UNITED STATES PATENT AND TRADEMARK OFFICE

10/692,442

Office Action Summary	Application No. 10/692,442	Applicant(s) WHITTAKER ET AL.	
	Examiner William V. Gilbert	Art Unit 3635

Figure 9 from Christy

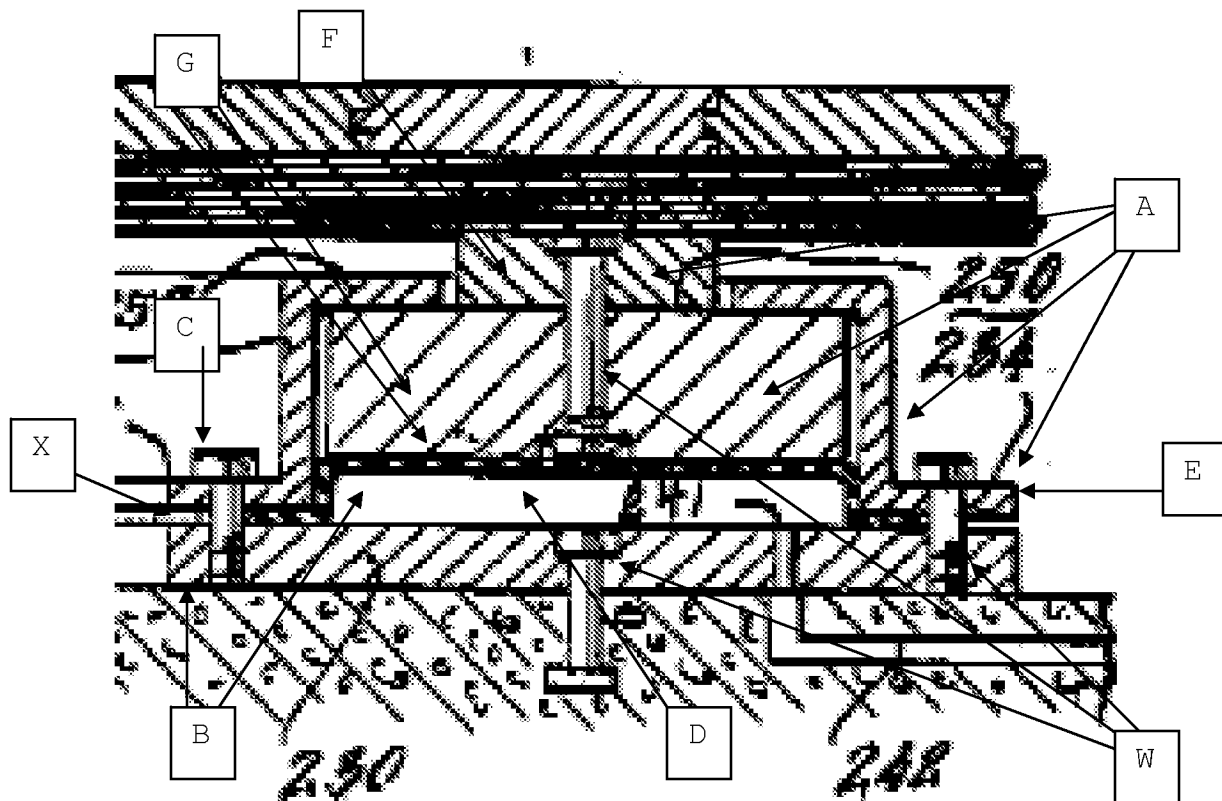
Claim 1: Christy discloses an apparatus for isolating and leveling a machine foundation with respect to a substructure comprising a rigid enclosure (Fig. 9) having a substantially hollow upper portion (see "A" from attached Fig. 9, below, the spacers show that it is substantially hollow) telescopically adjustably connected to a substantially hollow lower portion ("B" below) to provide for various sizes of the enclosure;; means for rigidly connecting the upper portion of the enclosure to the lower portion ("C" below) for fixing the position of the upper portion with the lower portion and means for providing leveling adjustment ("D" below; the inflatable portion) of the foundation.

Claim 2: the upper portion has a flange ("E" above) having an aperture extending therethrough (the bolt is in the aperture) and the lower portion has an anchor ring (230; see Fig. 9, generally where it is ring-shaped) with at least one rod (the bolt, "C" above) connected thereto and extending through the aperture in the flange above the upper portion, and a slip joint (the connection between the upper and lower sections is a slip joint) connected to the flange of the upper portion for releasably connecting the rod to the flange.

Claim 3: the lower portion has an anchor ring (230; see Fig. 9, generally where as shown this is a ring-shaped device, the upper surface extends into the interior as it is a part of the interior,) a bearing member ("F" above) within the enclosure and adjustable connecting to the anchor ring (via the leveling means) to provide a leveling adjustment of the foundation, and a support member ("G" above, including inflatable portion) in contact with the bearing member and engageable with the substructure. The two members "engage" via the lower portion.

Claim 9: Christy discloses an apparatus for isolation and leveling comprising a rigid enclosure connectable to the machine foundation having a substantially hollow upper portion ("A" above) and a substantially hollow lower portion ("B" above) telescopically connected to one another, the lower portion having an anchor ring (230) that extends into the interior of the enclosure (the upper surface of the ring extends into the enclosure,) a bearing member ("F" above) disposed within the enclosure above the anchor ring, a plurality of fasteners (see "W" above) that connect the bearing member to the anchor ring in a vertically spaced relationship (see Fig. 9) for vertical

adjustment of the anchor with the bearing member (the members can be loosened or tightened as needed for adjustment,) and a support member ("G" above and leveling means) in contact with the bearing member and engageable with the substructure for isolating the machine foundation from the substructure.

Claim 21: the upper portion is tubular (it is in the shape of a ring, which is tubular) and having open ends (there is an open end on each side of the bearing member), the lower portion is substantially tubular (it is in the shape of a ring) and having open ends (see "X" above; the joints between the upper and lower portion on each side is an open end.)

Claim 24: the anchor ring has an inner perimeter (proximate "X") and the fasteners ("C" above) are arrayed around the anchor ring adjacent the inner perimeter.
